The authors present an analysis of two sets of observations of, among other things, sediment concentration and velocity in the hyperturbid Ems river. Their aim is to show the fluid mud (FM) dynamics on tidal and fortnightly timescales, where especially the fortnightly aspect is new, as well as the different tidal dynamics during spring and neap. On a tidal scale, they identify various stages and describe the ebb-flood differences during spring and neap. On the fortnightly scale they identify FM building up and breaking down with the spring-neap cycle.

I think this manuscript could be valuable to the research community but given the possibly big gaps in the reasoning, I would say that very major changes are needed. Kind regards,
Yoei Dijkstra

Figure 1: reconstruction of an along channel section along the thalweg and based on the NLWKN stations on 27 Aug. 2019, using the maximum measured SSC at the stations during over the tidal cycle. Own preliminary results by the reviewer.

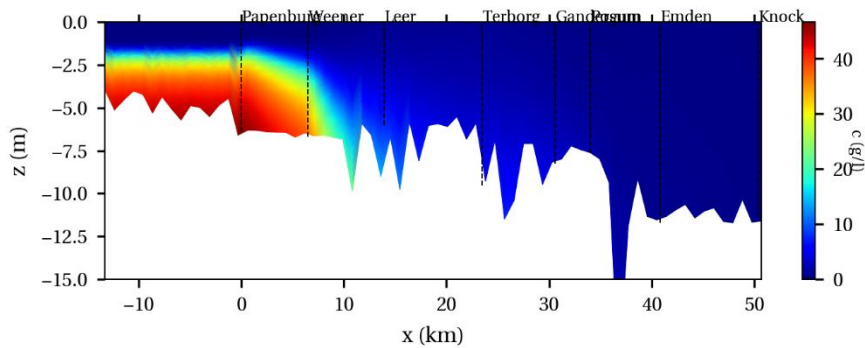
I would suggest another potential contestant: along channel dynamics. I looked at the observations from the permanent measurement stations and a simple reconstruction based on linear interpolation in the along-channel direction gives the *maximum* concentration during the tide on Aug 27 2019 (neap tide) in Fig 1 below. In Leer, the maximum reconstructed SSC in the thalweg (based on a very simple vertical model) is ~ 15 g/L, so sensibly 10 g/L is not reached a bit on the flanks. The FM is not gone though, but just slightly more upstream, and measuring in Weener could have provided a different result. It could still be that vertical dynamics is important here, but it also seems that you are measuring right on the edge of the ETM, so along channel movement of the ETM could also be the key here.
